Since last June 2012 a new snipe LoZelo is waiting for racing held by the fundamental 1st rule of the SCIRA Rulebook.

LoZelo italian snipe builder has created a new fore deck using 11.2 rule of the SCIRA (Maximum crown of deck 127 mm (5'')).

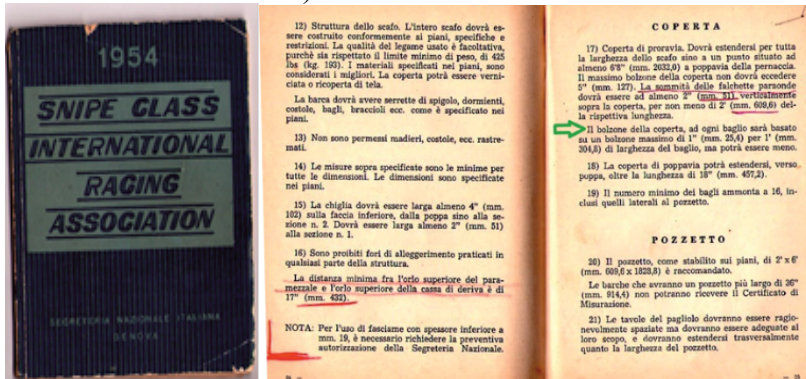
Green area shows the placement of forestay as allowed by the regulations.

Snipes, currently racing, have different deck crown in forestay zone, so that heights of intersection point stay-deck from sheer line are strongly different one unlike the others.

Which is the prescribed height of the deck in forestay zone for all snipes currently racing?

This question have only one possible answer in 11.2 item (max crow deck mm 127). LoZelo 's deck shape completely respects the maximum tolerance allowed in 11.2 item. The SCIRA regulator made these two tolerances (horizontal 279/330 mm and vertical 127 mm) in order to help each snipe builder or designer to find the best position by using their own talent.

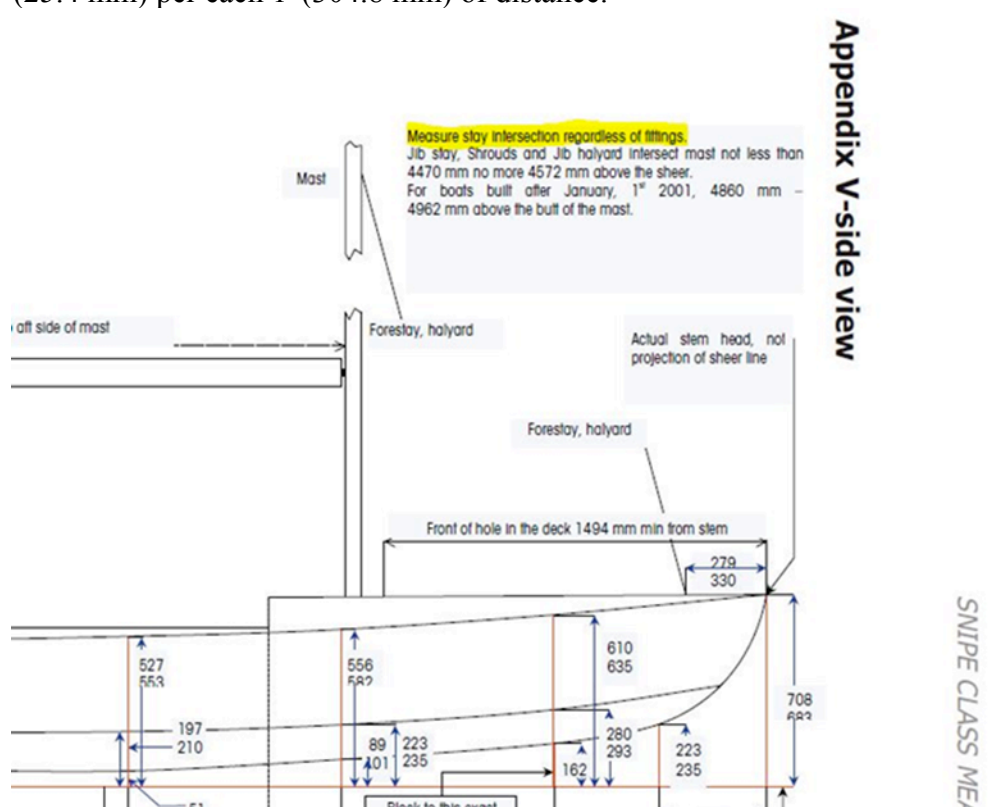
Proof of this fact is the elimination in current Official SCIRA Rulebook 2009-2012 of one paragraph art. 17 highlighted with green arrow in the figure below (content retrieved from an old SCIRA Rulebook).

This paragraph shows that the maximum height of the deck in any cross section was 1" (25.4 mm) per each 1' (304.8 mm) of distance.
